Subject: Revised Feasibility Study and Corrective Action Plan
Fuel Distribution System, Section BR11-1
Buildings 127A, 127B, and 128A
Riley Avenue, Presidio of San Francisco, San Francisco, California

REVISED FEASIBILITY STUDY AND CORRECTIVE ACTION PLAN

**Fuel Distribution System | Section BR11-1
Buildings 127A, 127B, and 128A**

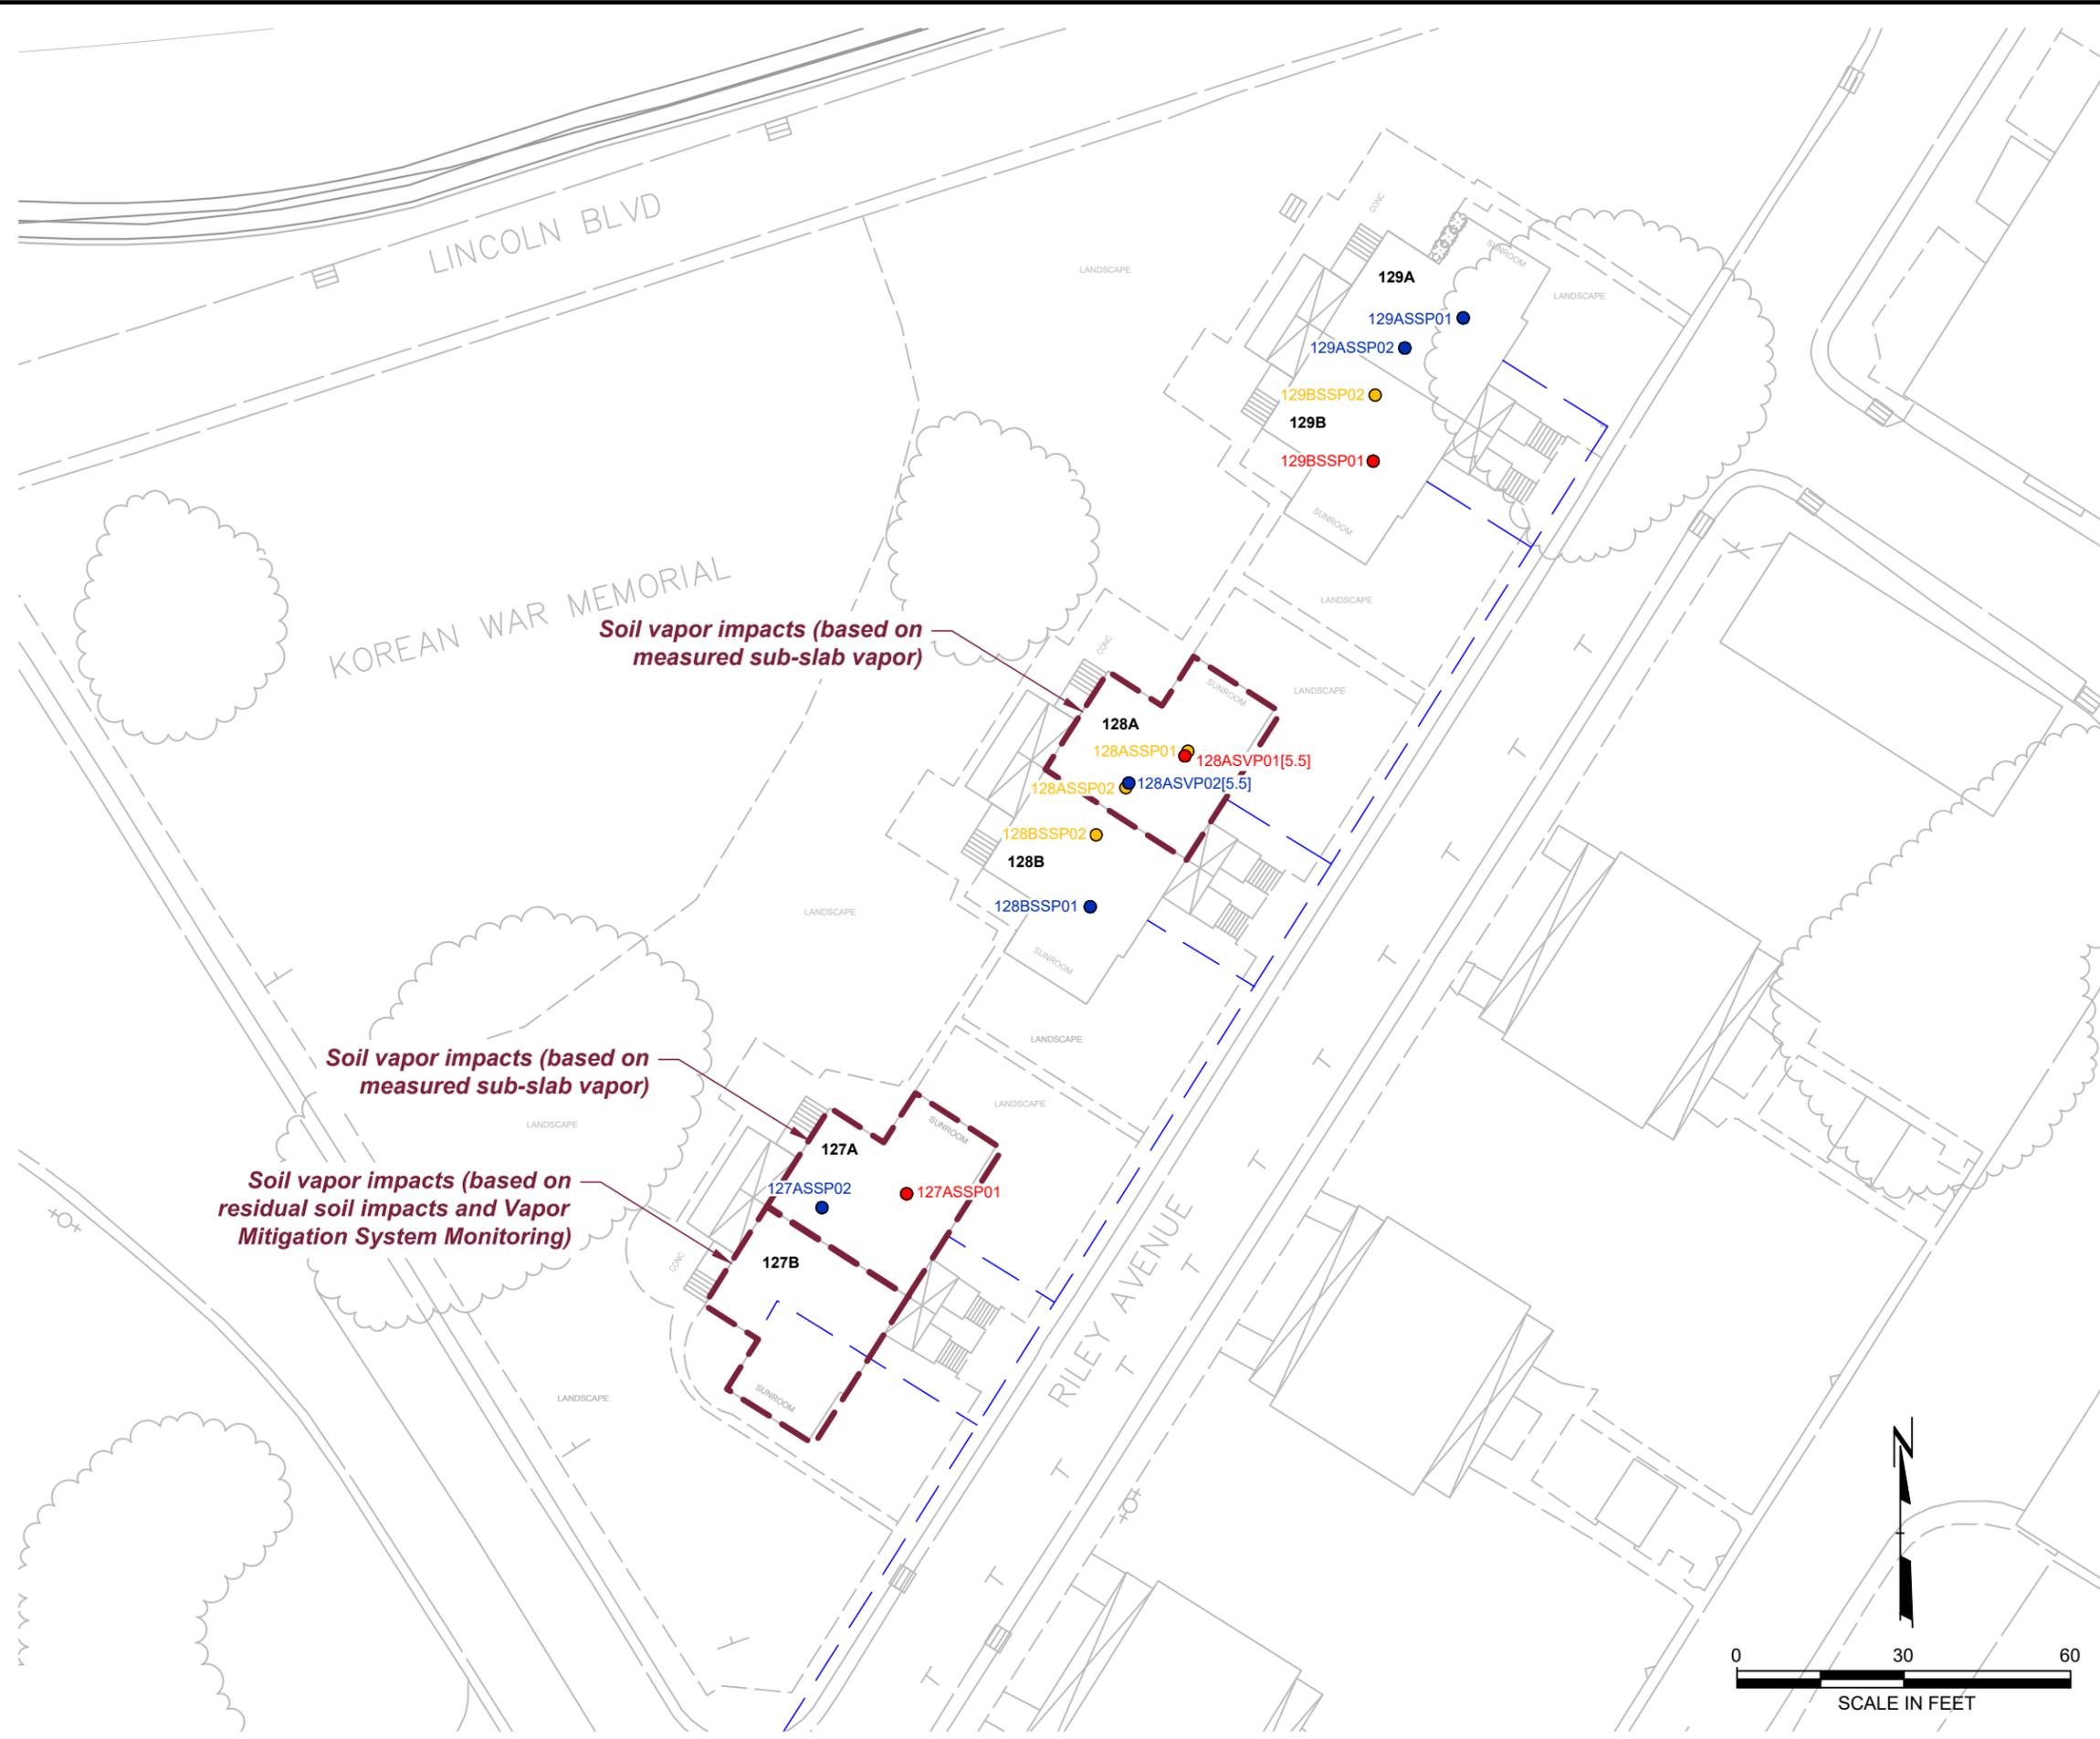
Comment 1: The FS/CAP must be acceptably revised to reflect the potential soil VI hazard, including revision of Figure 5 to show the presence of soil vapor impacts at Unit 127A.
February and July 2018 indoor air sample analytical results indicate that there is currently no unacceptable risk to residents of Unit 127A from soil VI. However, the subslab soil vapor concentrations of diesel-range organics (TPHd) and gasoline-range organics (TPHg) range up to 30,000 $\mu\text{g}/\text{m}^3$ and 190,000 $\mu\text{g}/\text{m}^3$, respectively, indicating significant potential risk (i.e., a non-cancer hazard index of approximately 61 for TPHd and TPHg).

Comment 2: The FS/CAP must be acceptably revised to reflect the potential soil VI risks at Units 127A and 128A, including revision of Figure 5 to show the presence of soil vapor impacts at Unit 127A and 128A.
